ADDENDUM TO
SPECIFICATIONS ENTITLED
"SPECIFICATIONS FOR
THOMAS COOPER LIBRARY ROOF REPLACEMENT
UNIVERSITY OF SOUTH CAROLINA
COLUMBIA, SOUTH CAROLINA
PROJECT NO. H27-6094E"

ADDENDUM NO. 1

AUGUST 28, 2012

D9 EXPANSION JOINT DETAIL - ADDENDUM NO. 1

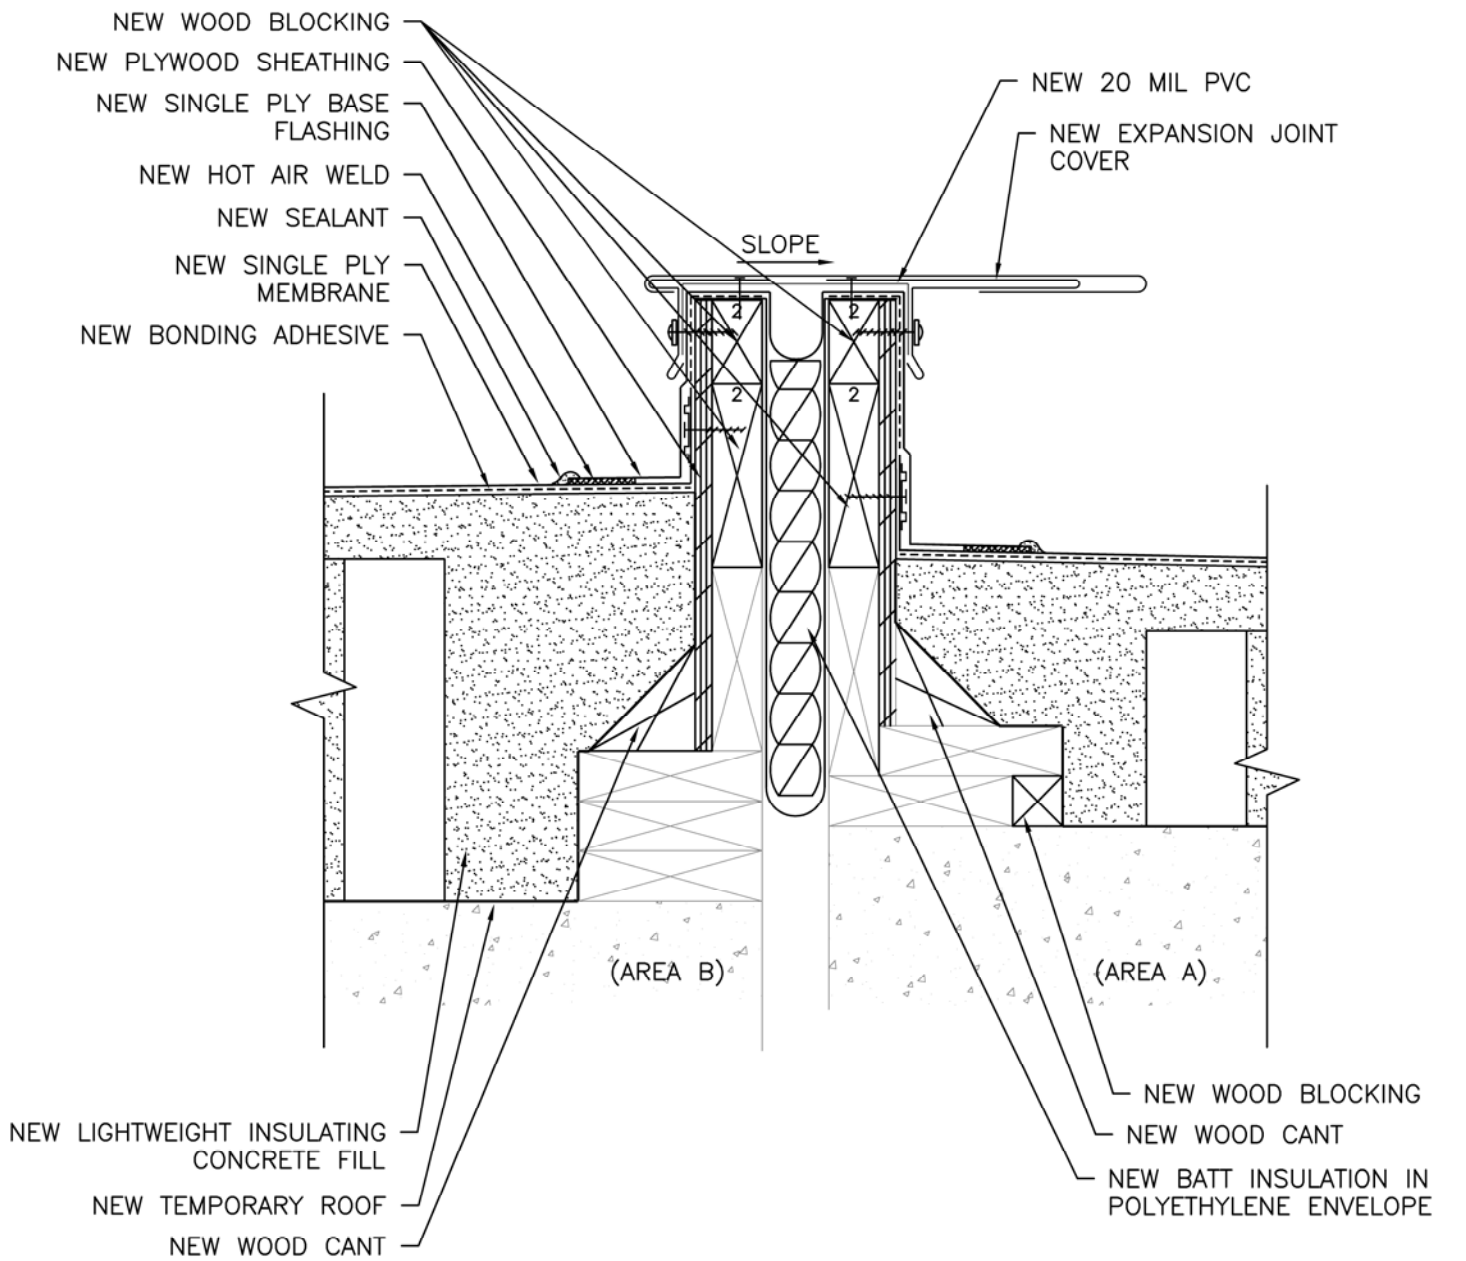
8. Delete Detail D9 and replace with new Detail D9 (Addendum No. 1)

NOTE: EXPANSION JOINT BLOCKING HEIGHT AT AREA B TO BE APPROXIMATELY 5". FIELD VERIFY TO FIT UNDER EQUIPMENT SCREEN WALL.

Prior to installation of the PVC stripping, continue the thermoplastic membrane over the expansion joint, creating a bellows equal to the width of the expansion joint.
